Downriver Medicine Associates

Re: License No. 21-32486-01  
Notification of removal and addition of Areas of Use

We have enclosed the original diagram and an updated diagram of the Areas of Use. The stress lab originally identified on the diagram was moved to a different room in the office.

NUCLEAR MEDICINE DEPARTMENT

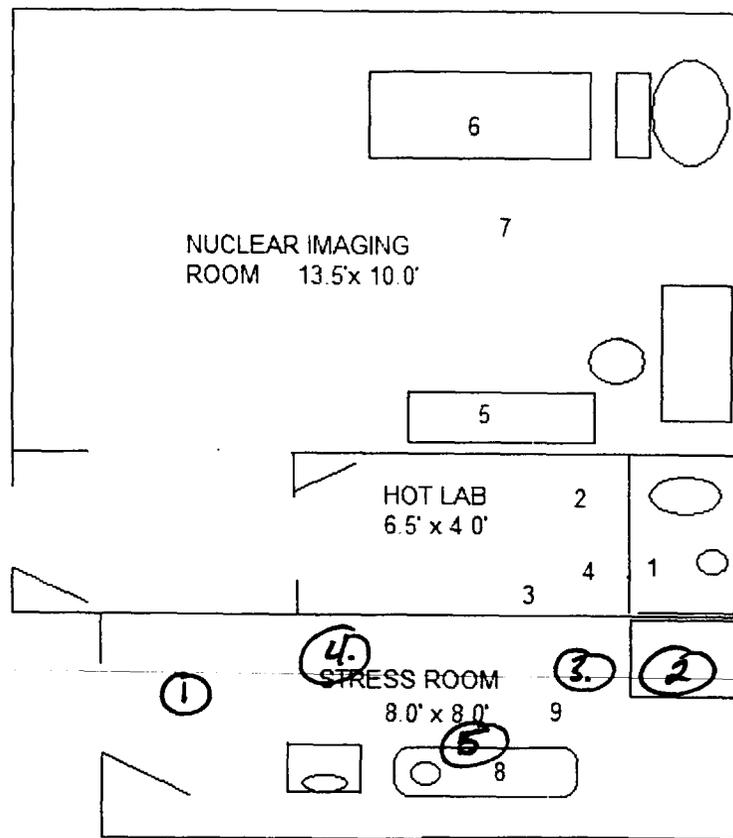
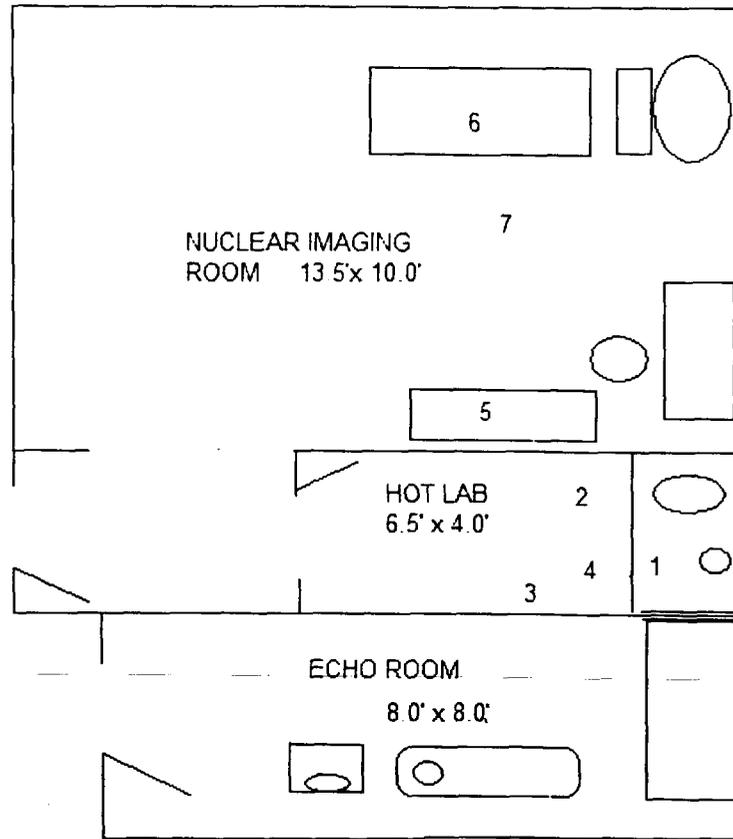
The last date of use of radioactive material in the original stress room was July 6, 2007. Only the radionuclide Technetium 99m was used for diagnostic testing at this facility and no sealed sources were used or stored in this stress room. Please note that a closeout survey of the original stress room was performed on August 22, 2007.
